Subject: Klamath Facilities Removal - Sept 2011 (EIS/EIR).

Subject: Klamath Facilities Removal - Final Environmental Impact Statement / Environmental Impact Report, Sept 2011 (EIS/EIR) - Comments.

Subject: Klamath Facilities Removal - Final Environmental Impact Statement /
Environmental Impact Report, Sept 2011 (EIS/EIR) - Additional Comments.

Subject: Klamath Facilities Removal - Final Environmental Impact Statement / Environmental Impact Report, Sept 2011 (EIS/EIR) - Comments.

The earth dam's Cross Section - Iron Gate's Elevations are shown.

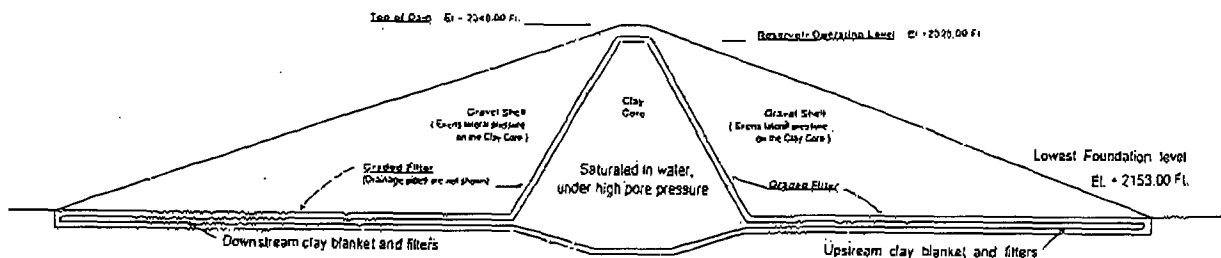
1.0. Scientific proof: Below is an earth dam's general cross section with the Iron Gate's elevations. This is from my enclosed letter to BOR dated November 2011.

1.1. During dam's construction, clay is "unconfined", but compacted "stone hard" with low moisture content. Clay attains high strength by expelling the voids and interlocking its particles. Its strength makes it possible to design the dam so that the "unconfined" clay could resist the Gravel's pressure during dam's construction. It is safe to fill the reservoir, only after "confining" the clay under the weight of the dry earth on top.

1.2. During the dams' operation, water under pressure enters the microscopic space in between the clay particles, saturates the clay and creates 'high pore pressure' (*the pressure of water between the microscopic clay particles*). This pore pressure is eventually in hydrostatic equilibrium with the outside water pressure. This is a high 174 ft water pressure for the Iron gate dam.

Clay's strength indeed decreases with more water, but the clay is "confined" and will not yield to Gravel's pressure because it is "confined." The dam is safe; the clay will not yield as long as the clay is "confined."

The earth dam's Cross Section during breaching.

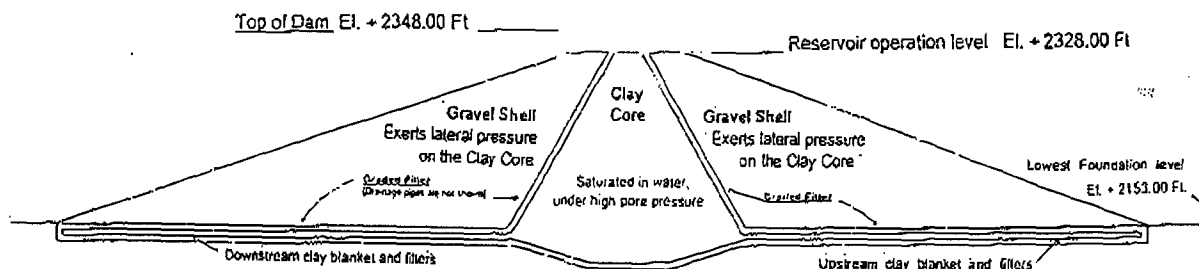
1.4. Prior to breaching, clay core is "confined" (i.e., restrained on all sides, so that it will not yield to external pressure or be squeezed out). It is designed to resist the Gravel shell's pressure and the dam is safe.

1.5. During the "proposed action" the wet clay core will become "unconfined", it will yield to external pressure and be squeezed out. The dam will collapse catastrophically.

A general cross section of an earth dam, during breaching, with the Iron Gate's Elevations is reproduced below, from my enclosed letter to the BOR, dated November 18, 2011..

The earth dam's Cross Section - Iron Gate's Elevations are shown.

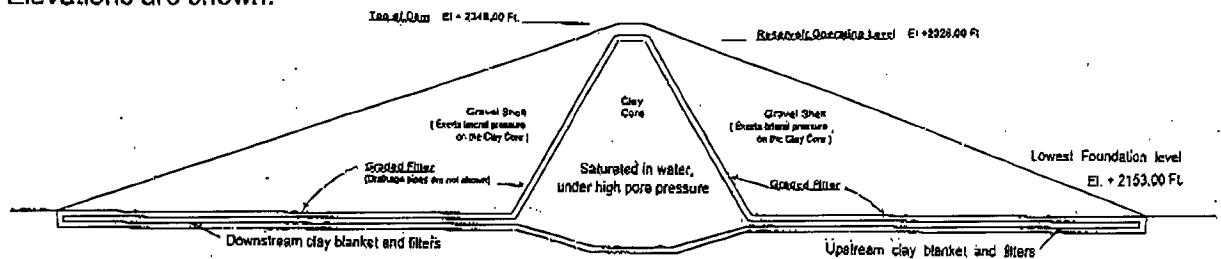
1.0. The Scientific Proof: Below is an earth dam's general cross section. Iron Gate's Elevations are shown.

The earth dams have three sections.

- An inner "Clay Core" to prevent reservoir water from leaking through.
- "Filters" on both sides of the "Clay Core." They prevent clay particles from escaping. They also safely confine the clay below the weight of the dry earth on top.
- An outer "Gravel shell" that exerts lateral pressure on (*in other words, squeezes*) the wet "Clay Core." The "Gravel shell" gives stability to the dam.

1.1. During dam construction, the clay is compacted "stone hard" with low moisture content, to resist the Gravel shell's pressure. Below are a few characteristics of clay.

The earth dam's Cross Section during breaching.

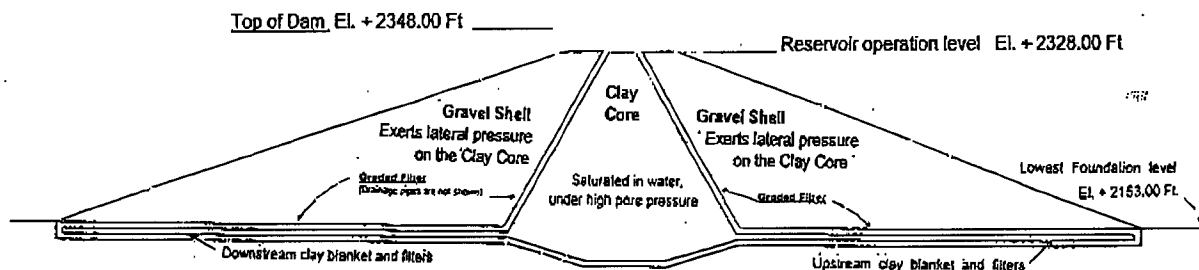
1.4. Prior to breaching, the wet clay core is "confined". It is designed to resist the Gravel shell's pressure and the dam is safe.

1.5. During the "proposed action" to remove the Iron Gate and J.C. Boyle earth dams, the wet clay core will become "unconfined." It will yield to the Gravel shell's pressure and the dam will collapse catastrophically.
